Re: Florida Power & Light Company  
Proposed Turkey Point Units 6 and 7  
Docket Nos. 52-040 and 52-041  
Response to NRC Request for Additional Information Letter No. 081 (eRAI 7804)  
SRP Section 02.05.01 – Basic Geologic and Seismic Information

**NRC RAI Letter No. PTN-RAI-LTR-081**

**NRC RAI Number: 02.05.01-36 (eRAI 7804)**

**NRC RAI Number: 02.05.01-37 (eRAI 7804)**

**Figure 1: Map of fault from Reference 2 and associated seismic profiles**

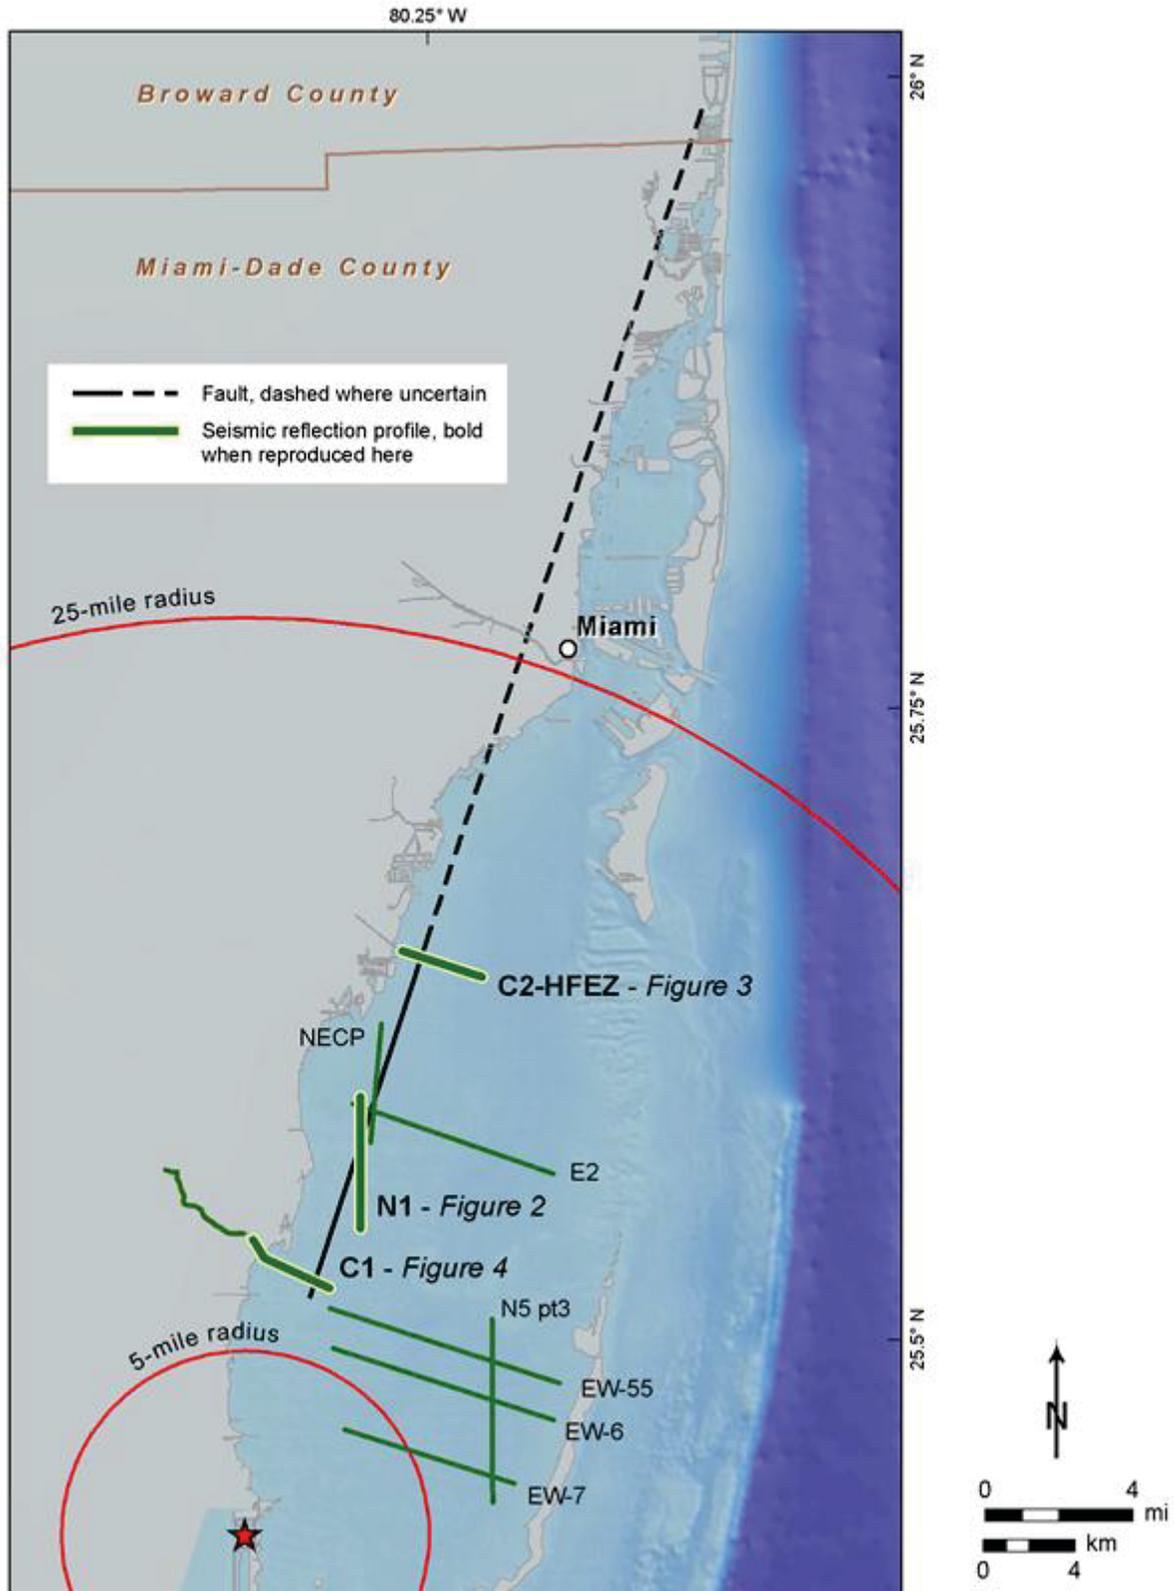
In Cunningham et al, 2012, approximately 210 km of high resolution marine seismic data reveal normal and reverse faults in Biscayne Bay, within 25 miles of the site. One of these faults is identified on 5 seismic lines and extends about 10 miles, striking N, NE. The authors interpret this fault as a vertical normal fault offsetting the top of Arcadia formation. The fault appears to project directly to the TPNPP. Staff also notes that because the fault appears to offset the top of Arcadia Formation, the age of movement would be about middle Miocene, but might be as young as early Pliocene (5.3 Ma). Staff also notes that this tectonic structure is not included in the TPNPP FSAR.

- a) In support of 10 CFR 100.23 please provide a discussion of this tectonic feature with respect to TPNPP and integrate into the regional tectonic setting for the TPNPP COLA.
- b) Does this fault fit the characteristics of a strike-slip fault with component of dip slip? If the fault is strike-slip how would you constrain age of latest movement?
- c) What is the possibility that this fault underlies the TPNPP site? If this feature underlies the site, what impact does this have on potential surface deformation?
- d) Update any RAI responses and associated COLA revisions that pertain to this topic.

Reference 1 (Cunningham et al., 2012) maps an unnamed, north-northeast-striking fault based on interpretation of offshore seismic reflection data obtained from five survey lines in Biscayne Bay. At its nearest approach, this fault is mapped to approximately 7 miles (11 kilometers) north of Turkey Point Units 6 & 7. This RAI requested more information about the geometry, kinematics, and timing of this structure than was available in Reference 1, which is an expanded abstract. Thus, FPL contacted the lead author, Kevin Cunningham, for additional information. Kevin Cunningham provided his recent peer-reviewed publication, Reference 2 (Cunningham, 2015), which includes additional information about this fault.

The fault was mapped on five seismic-reflection profiles with a trace length of approximately 10 miles (16 kilometers) in Reference 1, and extended as an uncertain (dashed) fault an additional 20+ miles (30+ kilometers) northward through a data gap to connect with a possible offset identified in seismic profiles at the Miami-Dade North District Boulder Zone Water Field in Reference 2. Reference 2 provides more recent and more detailed mapping and information about this structure (Figure 1), and hence much of the discussion that follows is based on updated and more detailed data presented in that more-recent publication. The remainder of this response is divided into four parts, a through d, to address each part of the RAI.

- c) The fault as mapped by Reference 1 and Reference 2 projects towards the Turkey Point Units 6 & 7 site. The southern extent of the fault as mapped by Reference 2 is roughly coincident with the location of seismic line C1, the southernmost profile that images the fault (Figure 1). Thus, the southern extent of faulting is not constrained by the data presented in Reference 2. Evaluating whether the fault projects beneath the site location is difficult given that the depths of site explorations are generally shallower than the top of the Arcadia Formation, which is the stratigraphically highest unit interpreted as faulted in Reference 2. Insufficient information exists to definitively exclude the possibility that this fault underlies the Turkey Point Units 6 & 7 site.

**Figure 1 Jewfish Creek/Lake Surprise Feature Location and Anomalies**

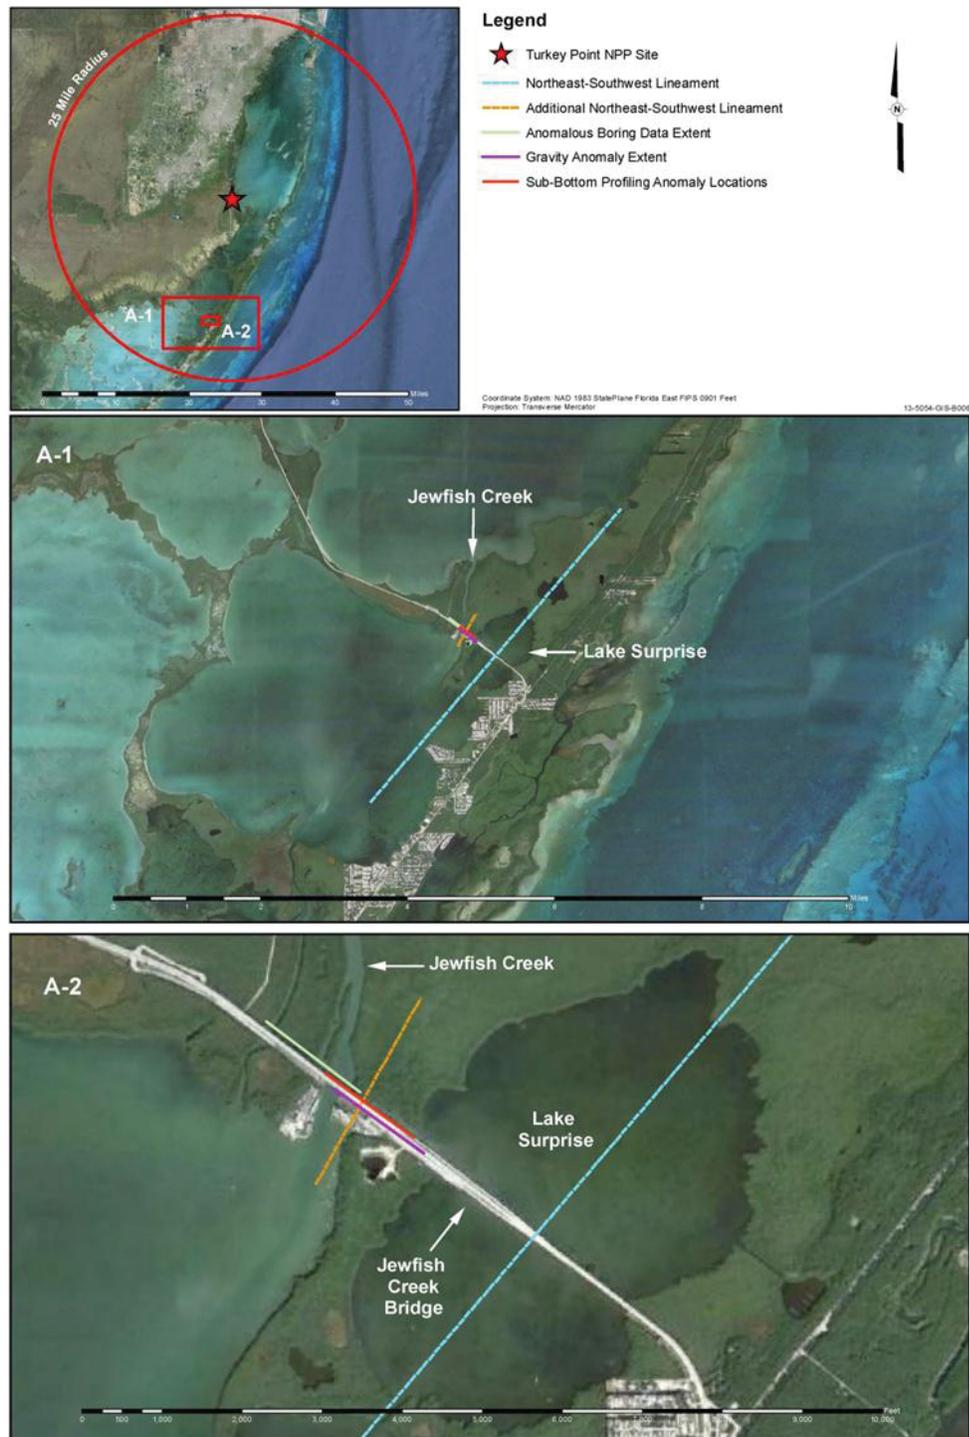
The Technos 2009 Geophysical Survey for Karst Characterization at Proposed Units 6 and 7 Turkey Point Nuclear Power Plant describes a filled sinkhole at Jewfish Creek, within 10 miles of TPNPP. Technos describes the filled sinkhole: The sinkhole at Jewfish Creek is ~1900 ft across and estimated to be more than 600 feet deep, based upon seismic and microgravity data. Borings and geophysical logging indicated open cavities within this paleocollapse feature up to 9 feet in diameter. Staff notes that a 600 ft deep sinkhole is well below the -350 ft sea level lowstand from Late Pleistocene glacial maxima. Staff notes that the Jewfish Creek sinkhole is also in a similar setting to TPNPP with respect to current and paleo shorelines.

a. In support of 10 CFR 100.23, please provide other relevant details regarding the Jewfish Creek feature. What stratigraphic formations does the sink hole impact? At what depth and in what stratigraphic formation were the open cavities found? Does the Jewfish Creek sinkhole represent hypogenic limestone dissolution (as described in Klimchouk, 2009) in an onshore location, near TPNPP?

a. Jewfish Creek and adjacent Lake Surprise (a shallow marine lake) are located approximately 27 kilometers (km) (17 miles [mi]) from Turkey Point Units 6 & 7 (Figure 1). Data from 34 geotechnical borings located along Jewfish Creek and in Lake Surprise (collected in 1994 to support design work for the Jewfish Creek Bridge) provided evidence for localized loose sand layers. Publishing as Benson et al. Technos Inc. (hereinafter referred to only as Technos) interpreted these loose materials as possible evidence for sediment transport (i.e., piping) into dissolution cavities (References 1 and 2). At some locations, drilling water (circulation) losses were also observed, suggesting voids and/or highly permeable sub-surface layers (locations of anomalous borehole data in Figure 1). For the most part, these water losses were concentrated at depths between 6 meters (m) and 30 m (20 feet [ft] and 100 ft).

with a deeper cavity. Technos (References 1 and 2) also noted that aerial imagery suggested a major northeast-southwest trending lineament within the gravity anomaly area and through at least five nearby lakes (Figure 1).

**Figure 7 Surface and Subsurface Karst Features in Southeastern Florida**

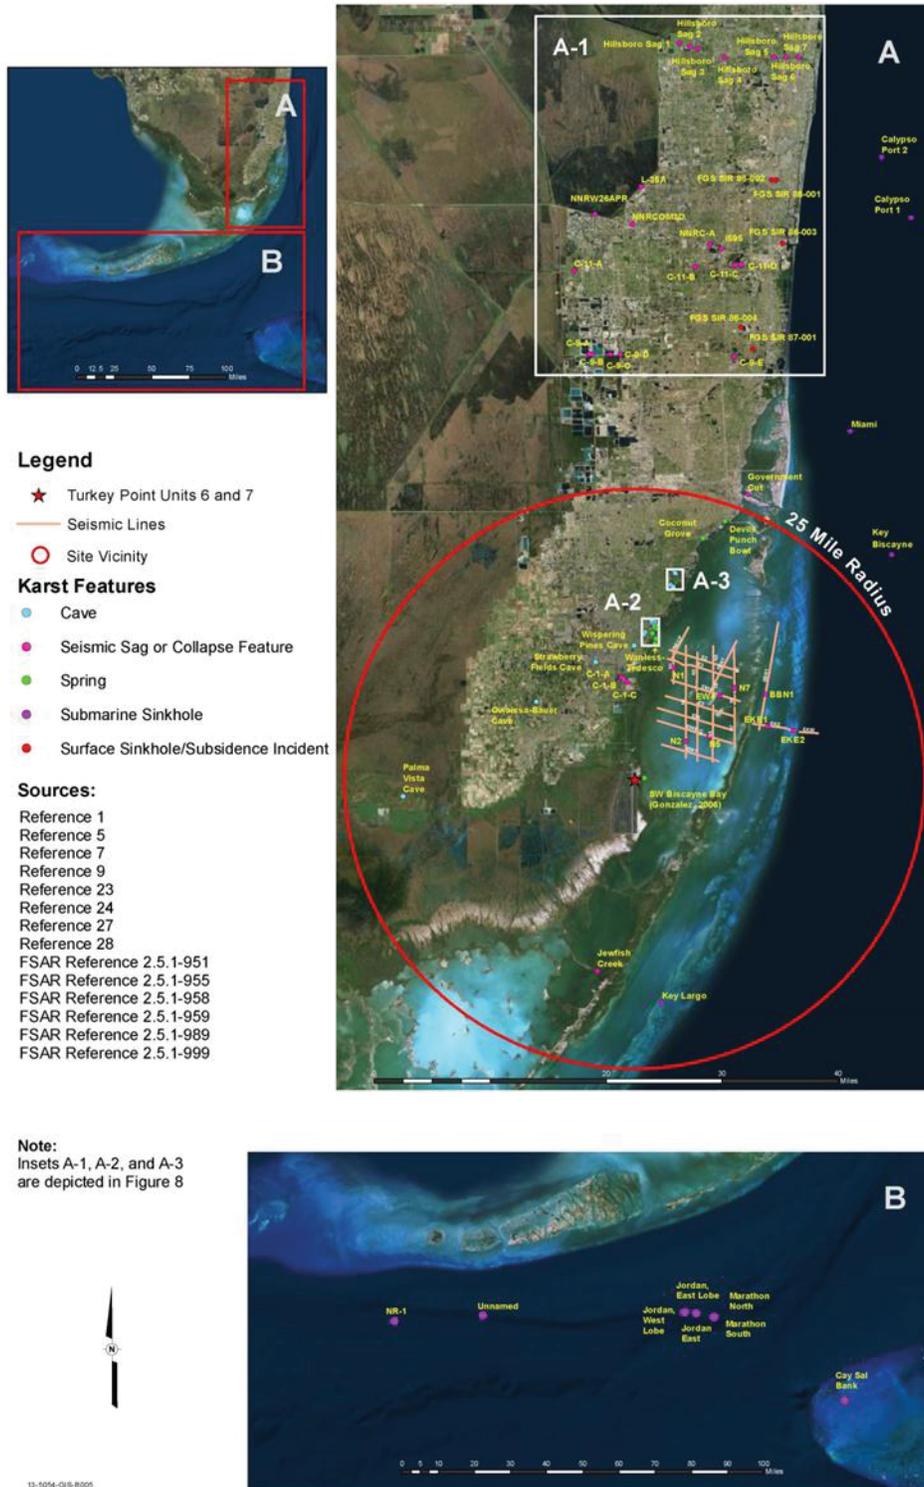
c. Please provide a map showing all dissolution features found in the TPNPP site vicinity, include the locations of the 12 subsurface seismic sags from Cunningham and Walker and the young sinkholes identified by Land and Paull (1995 and 2000). Update any RAI responses and associated COLA revisions that pertain to this topic.

- c. Significant dissolution features within the Turkey Point Units 6 & 7 site vicinity and in adjacent central and eastern Broward County are identified on Figures 7 and 8, and include caves, sinkholes, and springs, as well as paleo-karst collapse and sag structures. Notably, the latter features include the previously described Jewfish Creek/Lake Surprise collapse structure, and the sag systems described by Cunningham and Walker (FSAR Reference 2.5.1-958). Major offshore dissolution features (namely submarine sinkholes) are also identified on Figure 7, and are described below.

Aerial imagery for the shoreline near Turkey Point Units 6 & 7 from 1938 clearly captures an offshore spring and groundwater seepage only 1500 m (4921 ft) from the approximate site center-point (Figure 7). Gonzalez (Reference 28) relocated the seepage/discharge point in 2004, but did not observe flow. Generally though, the approximately relocated spring site was characterized by sediment-filled, seagrass-covered karst holes.

More significantly, Land et al. (Reference 21) and, later, Land and Paull (FSAR Reference 2.5.1-951) mapped nine submarine sinkholes in the Florida Straits, on the Pourtalès and Miami terraces (purple circles, Figure 7) at depths between 244 m and 575 m (800 ft and 1886 ft). Long and short axes and depths in the sinkholes average about 630 m (2065 ft) and 440 m (1444 ft) and 100 m (328 ft) respectively. Land et al. (Reference 21) (and Land and Paull [FSAR Reference 2.5.1-951]) interpreted the features as having formed underwater, and as rooted in Eocene and Oligocene limestones. Land and Paull (FSAR Reference 2.5.1-951) also suggested that some were possibly still active, given incomplete infilling.

ENTRIX, Inc. (Reference 32) specified that the southernmost Calypso feature (Calypso Port 1 in Figure 7) exhibited surface expression and thus indicates possible continued subsidence. In contrast, the northern sinkhole feature (Calypso Port 2) was evident only in the sub-surface.
